**Midwest States Pooled Fund Program
Quarterly Progress Report – First Quarter 2011
June 15, 2011**

Pooled Fund Consulting Summary

Midwest Roadside Safety Facility

March 2011 – June 2011

Figure 1. Wildlife Crossing Holes in Barrier

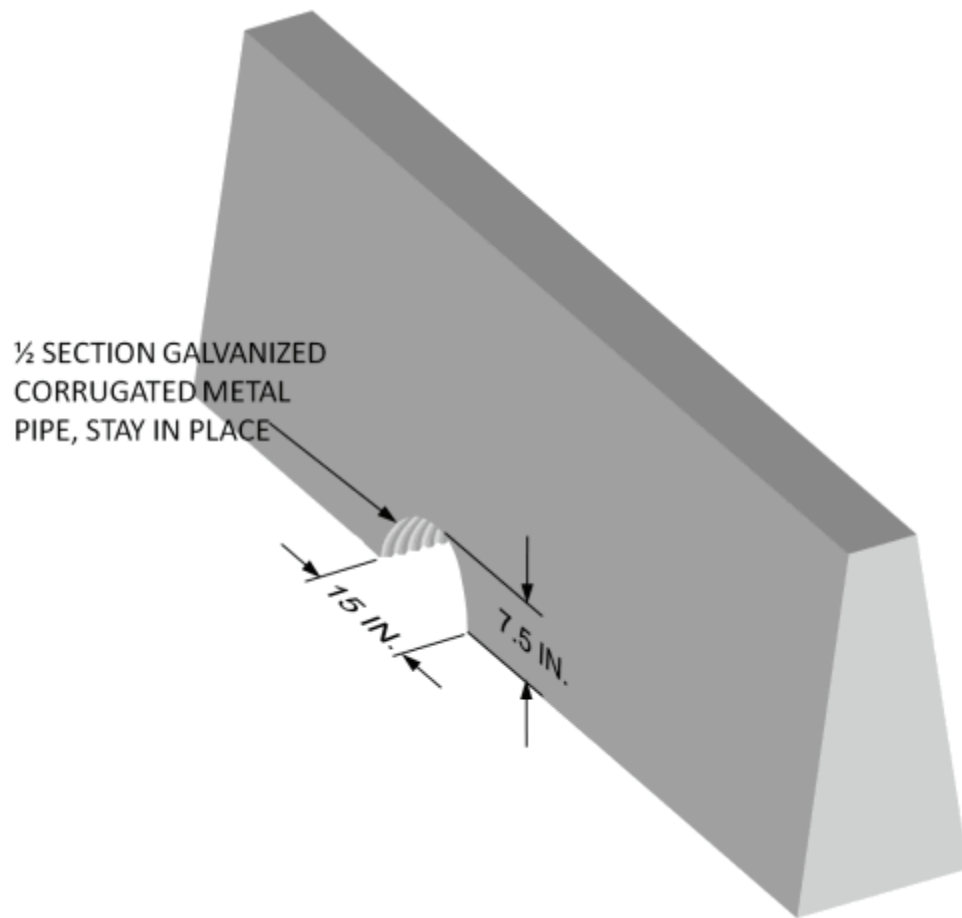
Our environmental specialist that handles threatened and endangered species has proposed a small wildlife crossing for single-slope barrier (shown below). He met with a contractor who ensured him the construction of the barrier as shown is entirely feasible, even for slip forming.

Given the diameter of the opening, I suspect this would neither add a snag point nor in any other way significantly decrease the crashworthiness of the barrier. I'm basing that on 3.4.2.1 of the Roadside Design Guide which states that single cross drainage structures with diameters less than or equal to 36 in. are traversable. Of course that is referring to inslopes and not barriers.

The dimensions shown below were those given to me, but I would also like to know if I could extrapolate your opinion to an 18 in., 21 in., or 24 in. CMP. Any diameter larger than that would begin to conflict with the reinforcing steel in the barrier.

Do you concur with my analysis of this situation?

It is well known that the structural capacity of a barrier is controlled by its ability to safely contain and redirect the heavy, taller vehicles which impact at high-speeds. Thus, a structural analysis could be performed to modify the barrier reinforcement in regions where drainage holes are desired. Drainage openings in concrete parapets should be acceptable as long as the hole does not interfere with the structural steel reinforcement and the barrier capacity is not weakened in this region. If the 42-in. tall, single-slope concrete barrier section is weakened with a lateral hole, then the longitudinal and/or vertical steel reinforcement surrounding this area may need to be increased in order to provide equivalent or greater barrier capacity.

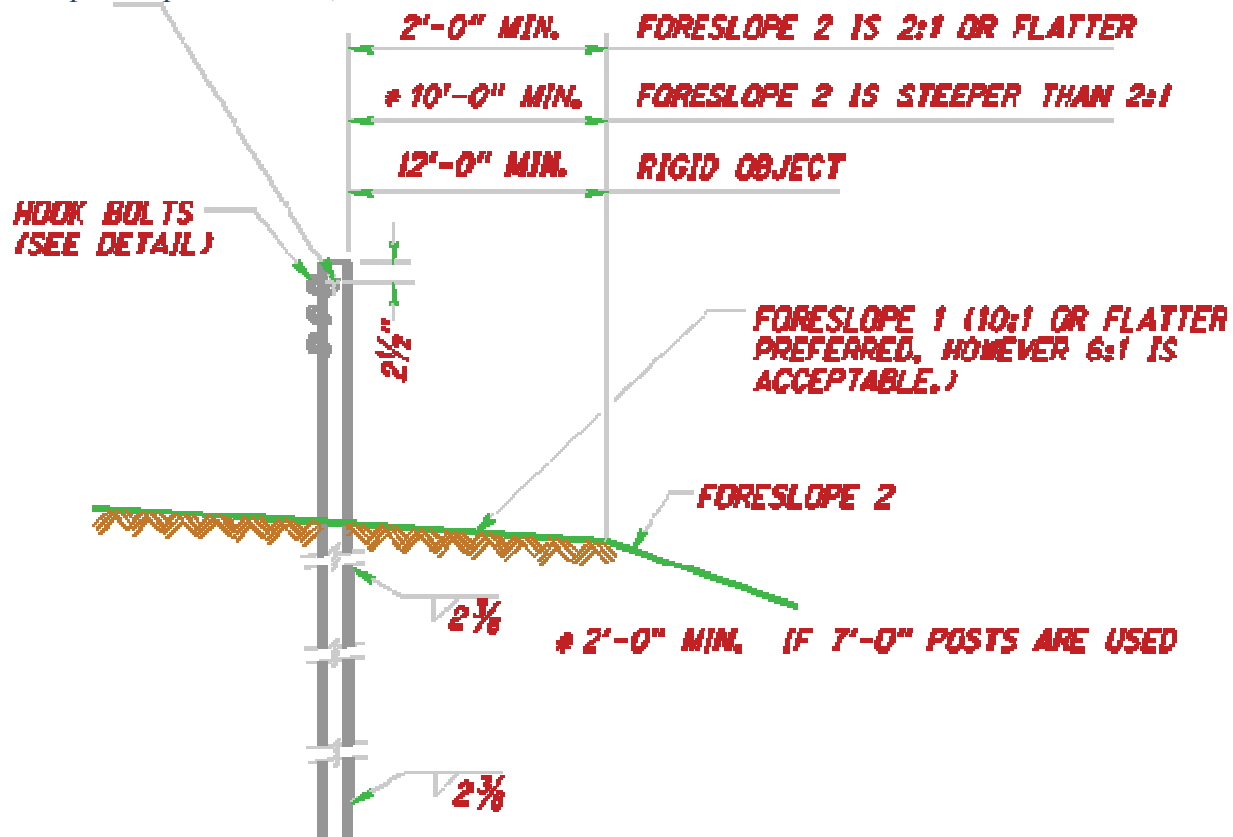
Most Low tension systems I am aware of have the bottom cable at 21". Some states have installed it with the top cable at 33" and with 6" spacing between the cables. For medians, lower cables are being used to address the underride issue. I am not aware of a crash tested system with the lower cable at 24".

How close can this be placed to a 2H:1V? And with what post spacing?

The testing of 4' post spacing @ 1' from a 1.5H:1V failure, and 4' post spacing @ 4' from a 1.5H:1V pass has us considering 4' post spacing at 4' from a 2H:1V – this is impossible in some locations with 2H:1V at the edge of shoulder.

I am not sure I have an absolute answer for you on this so I will give you some opinion. I believe the slope behind the cable is much less of a concern than the slope in front of the cable. The critical concern for cable is having the bumper of the vehicle engage at least one cable.

Typical Mn/DOT Bridge Barrier Placement

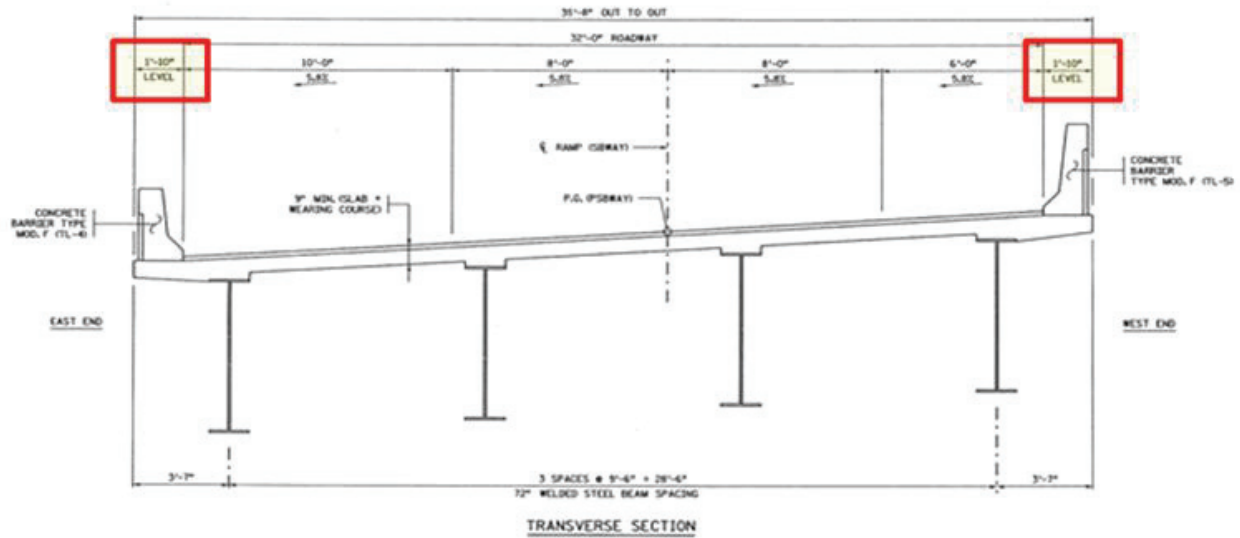
#1). Mn/DOT's current policy regarding placement of traffic barriers on bridges is to place them "plumb" or "level" as indicated in the drawing below.

Based on simulation and testing of 3 barrier types, the MwRSF suggested consideration of different guidance depending on the cross slope of the roadway/bridge;

TL-4 (32" Tall) Barrier

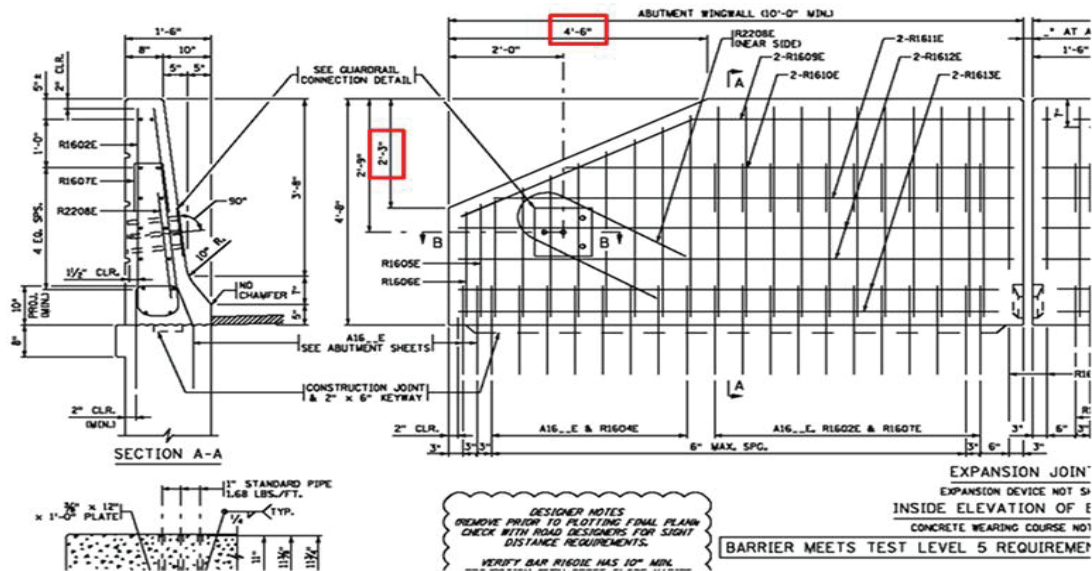
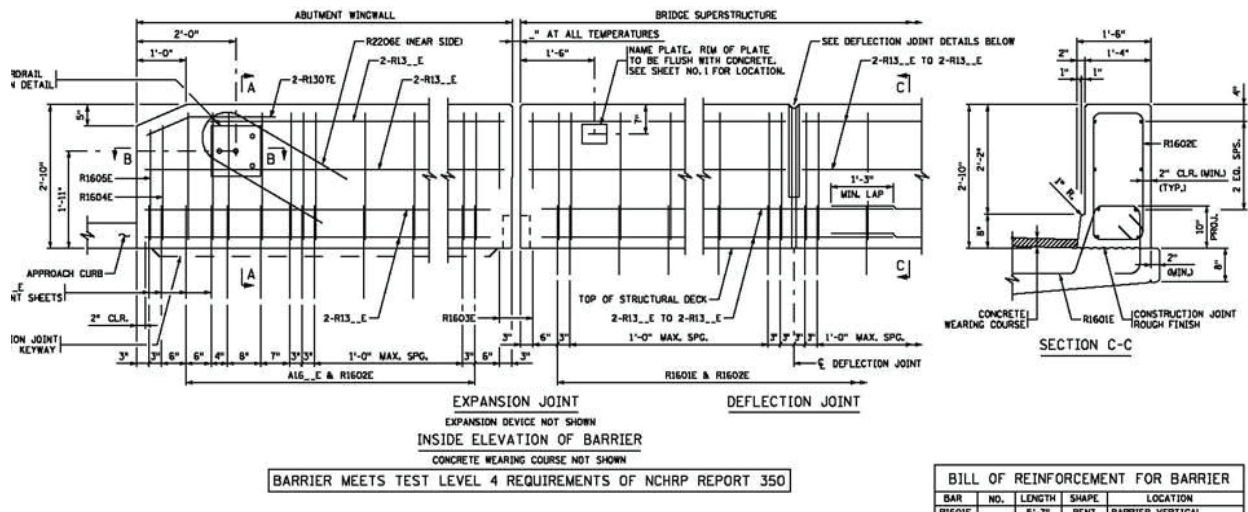
#3). At the end of a 32" or 34" tall concrete barrier, where it transitions to a guardrail connection, Mn/DOT details a slight slope (5V:12H) to the top of the barrier (see top sketch below). What is the appropriate slope or taper length that should be used when transitioning from a 42" (or taller, glare screen barrier that is 4'6" tall, 6V:12H taper) barrier to a guardrail connection?

The 5V:12H taper shown on the end of the 32" and 34" tall Mn/DOT TL-4 barrier has been crash tested and is okay to remain as is. End tapers for barriers taller than 34" should be modified to 1V:8H. The Bridge Standards Unit will put a "temporary hold" on tall bridge barrier standards (>34") showing the 5V:12H taper and begin the process of revising the standards to 1V:8H. #4). Mn/DOT has developed a vertical face bridge barrier as shown below. Other states have developed single slope barrier faces. What are the advantages, disadvantages and design considerations for the various shapes?

Figure 6. High Tension Cable Guardrail with a 1V:3H Slope Behind

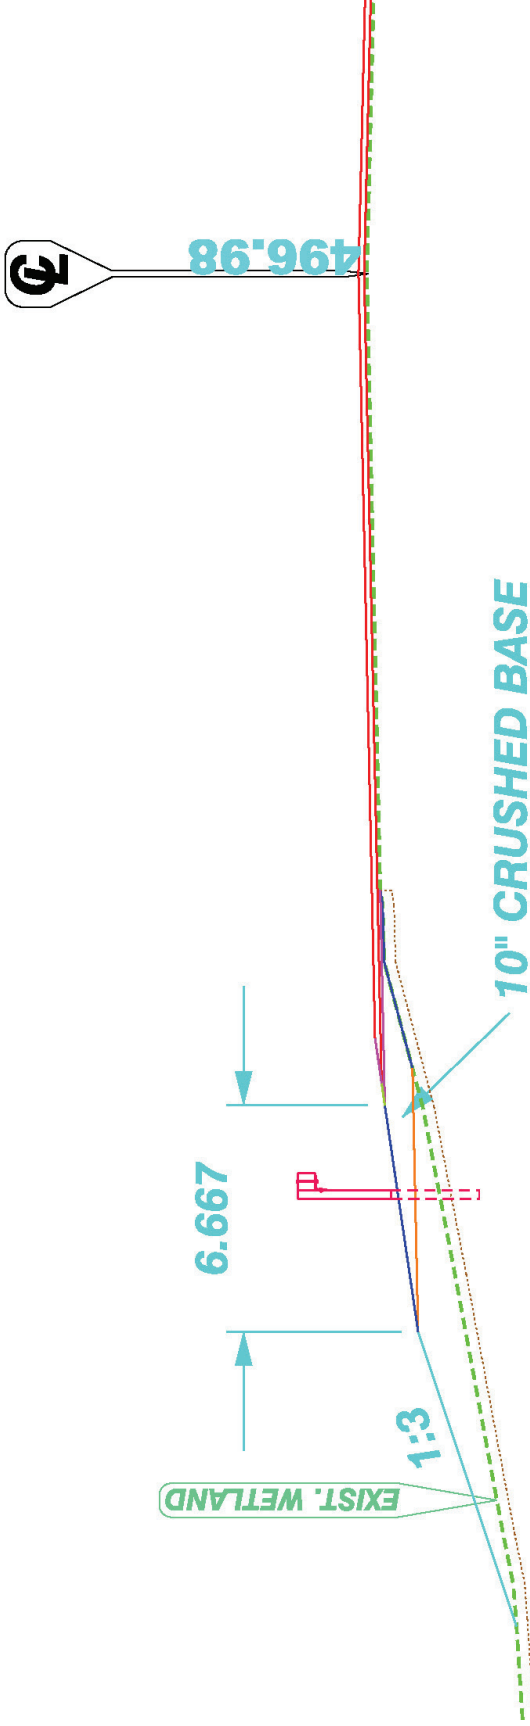
We have a situation where we want to place guardrail on a 1V:8H slope which extends a few feet behind the guardrail, before breaking off on a 1V:3H slope. Would a high tension cable guardrail such as Trinity's TL-3 system perform adequately in this situation? The standard system deflects up to around 9 feet (16 foot post spacing), so an impacting vehicle would be traversing the 1V:3H slope during redirection. I believe this deflection would not extend beyond the 1V:3H slope. Please see the attached drawing.

Figure 7. Alternative Wood Post Transition

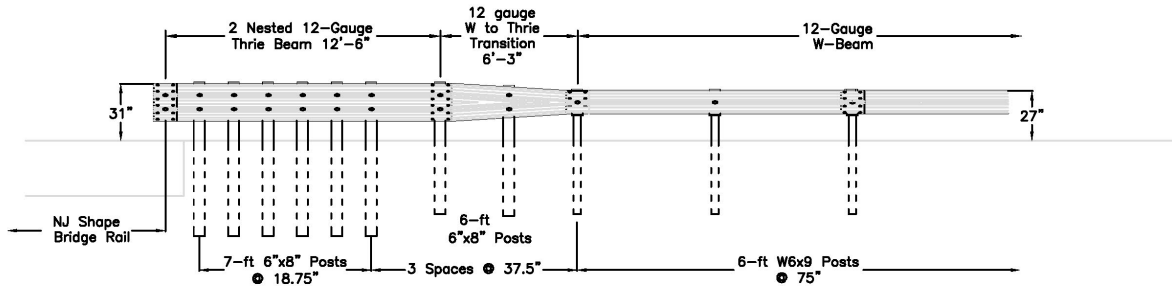
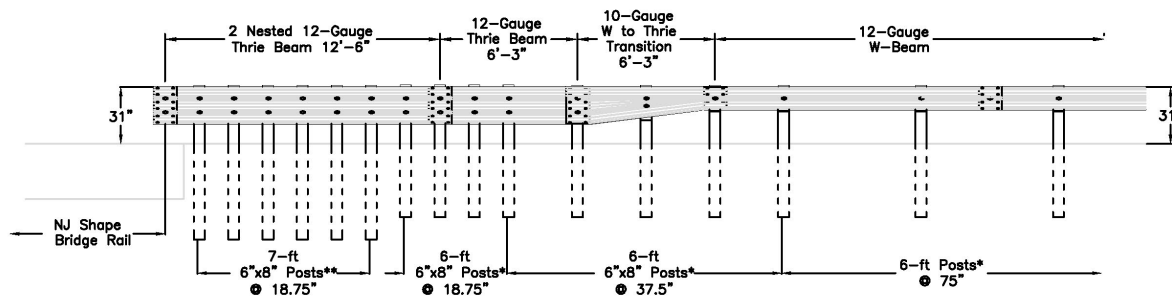
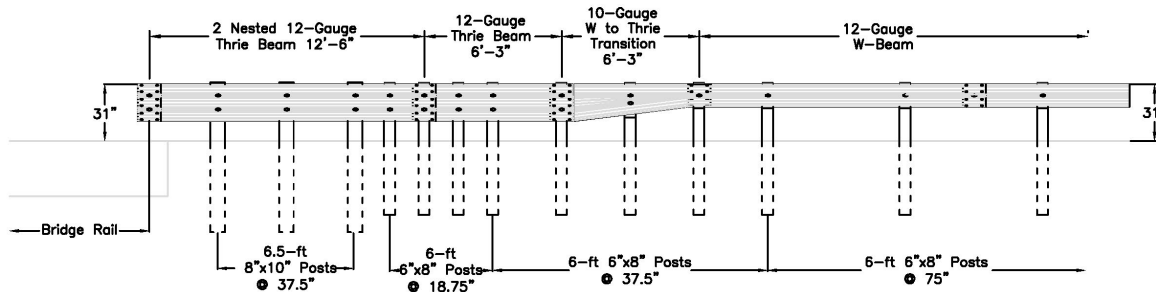
I have attached a drawing that shows the three most common bridge end post shapes that are encountered in Iowa. If you need exact dimensions on these, let me know. Type A on page one is the current bridge end post design and is the most common by far. If possible, we would like to be able to use the same AGT for all three types.

I have reviewed all of the FHWA accepted transition designs as well as the MwRSF tested transition designs. From this review, there seems to be two different styles of thrie beam transitions to concrete bridge rail:

1. Use posts similar to the line posts (W6x9 or 6"x8" wood posts) but with increased embedment depths at ¼ post spacing (18.75"). A prime example of this style of transition is the transition you are currently using.
2. Use significantly larger posts (W6x25, W8x24, or 10"x10" wood posts) at 37.5" spacing. These larger posts are typically chosen so that the first post adjacent to the bridge rail can be omitted for drainage purposes (see page 165 of the report you noted, TRP-03-210-10). However, do to the omitted post and the oversized transition posts need to compensate for the gap, the recommended stiffness transition had a length of 31'-6" to the US end of the W-to-thrie transition element. You expressed that you needed to stay at your current 25' length, so this probably is not the answer you were looking for.

The original approach transition utilized to developed the stiffness transition shown in report TRP-03-210-10 was designed for attachment to a steel post, thrie beam and steel channel bridge rail system. Thus, I would not recommend utilizing this transition for attachment to concrete barriers until further evaluation/crash testing proves its crashworthiness.

I have attached the recommended wood post alternative to the transition you noted from page 167 of the steel post transition report. The attached figure comes from the wood post transition report that is currently under in-house review at MwRSF and should be sent to the Midwest Pooled Fund States in the near future.
